**Permit Evaluation  
and  
Statement of Basis  
for  
MAJOR FACILITY REVIEW PERMIT  
Reopening – Revision 2**

for  
**Valero Refining Co. - California  
Facility #B2626**

April, 2005  
Revised September 2006 for Proposed Permit  
Issued for Final Permit, March 2007

The following drawing summarizes the proposed NOx Boxes for the sources covered by this application:

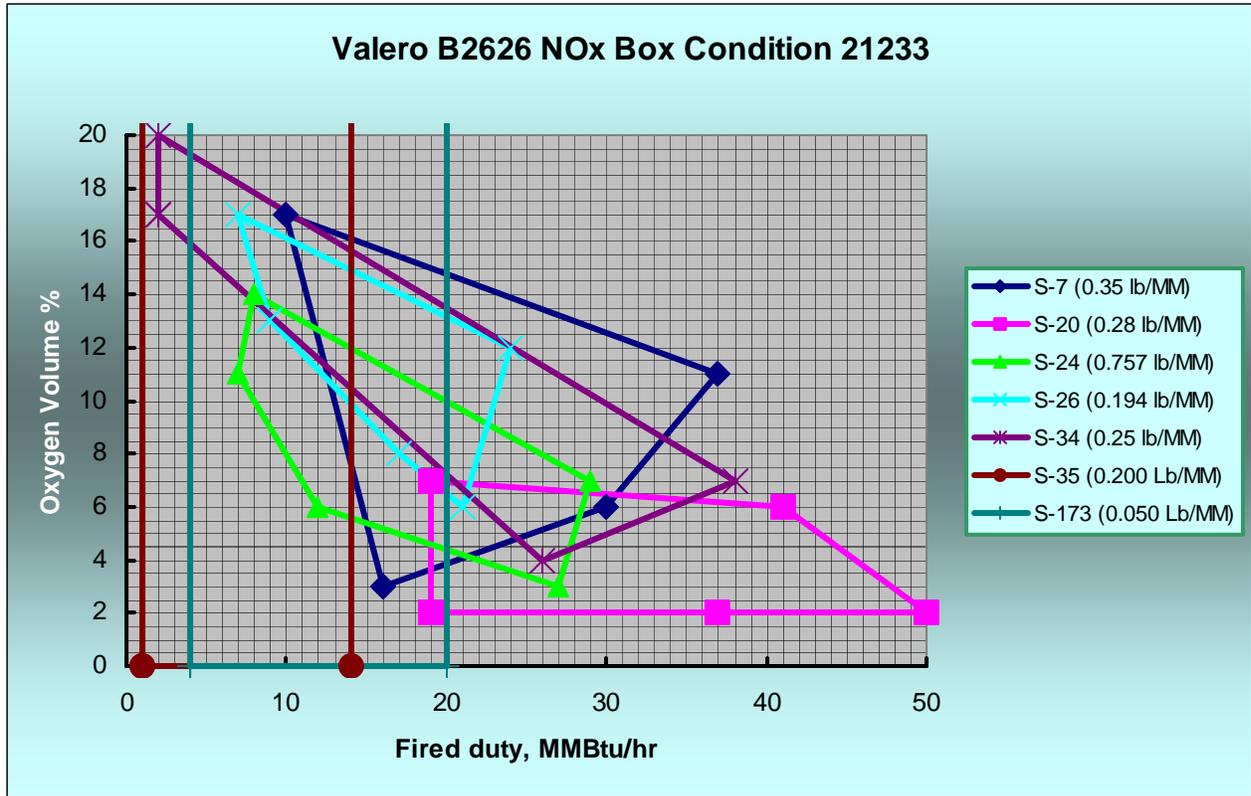
The proposed NOx Boxes are supported by source tests reviewed by the Source Test Section. All of the proposed operating ranges shown above are included in Rev. 2 of the Title V Permit.

The following diagram summarizes the changes to the S-20 NOx Box (Application 12701):

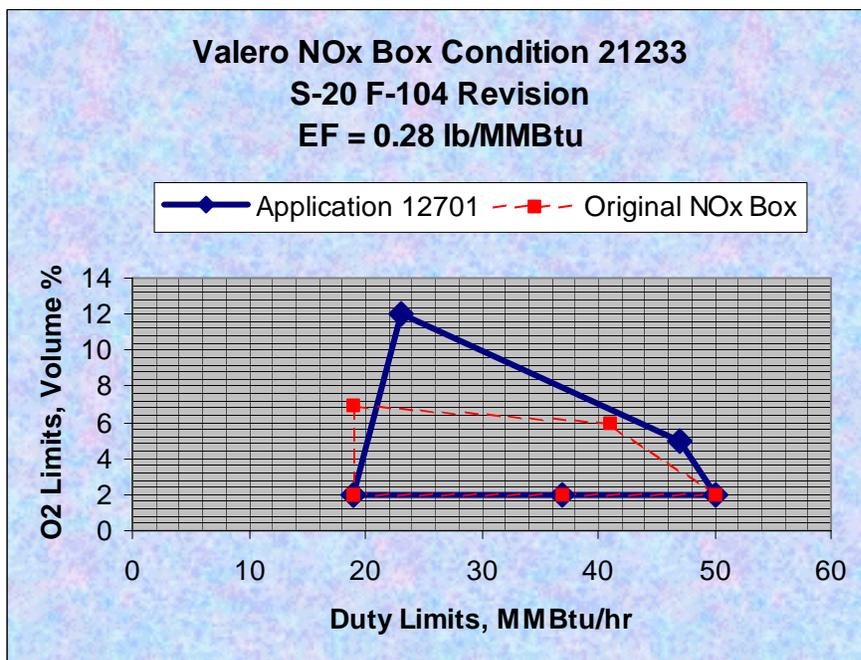
Application 12701, Revised NO<sub>x</sub> Box for S-20, granted September 12, 2005

Condition 21233 shown below is identical to the version shown in the draft Revision 3 of the Title V Permit, except for the revision to S-20 as approved in Application 12701, which was not included in the draft Revision 3 issued for Public comment (this S-20 change will be included in the proposed Rev 3 title V permit). The primary impact of this application 11307 will be the NOx Box operating parameters shown in Part 5A.
